Access Compliance Report

Public Rights-of-Way

(Curb Ramps)

Intersection ID: 54221	Main Street: MIDWAY_PARK_DR	Cross Street: NORTH_REA_PARK_LN	Location: NE
ADA ID: 09C8866F77CE	Ramp Type: Directional1	Initial Pass/Fail: Fail	Overall Compliance: No
		Severity Score: 1.25

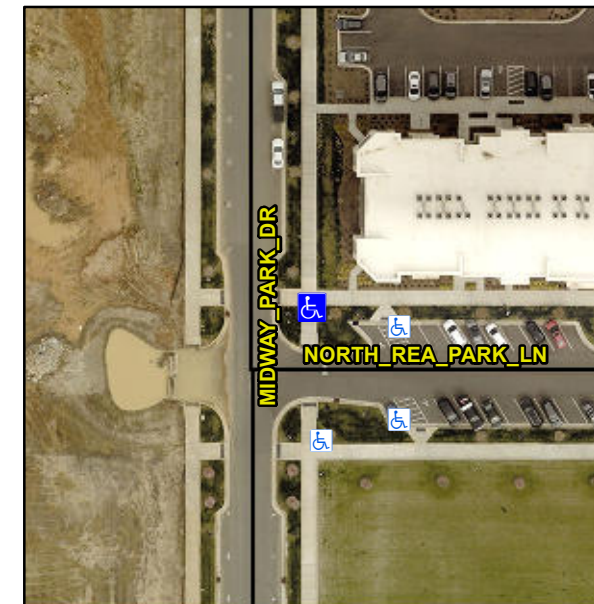
R304.5.3

Remove & Replace Entire Ramp.
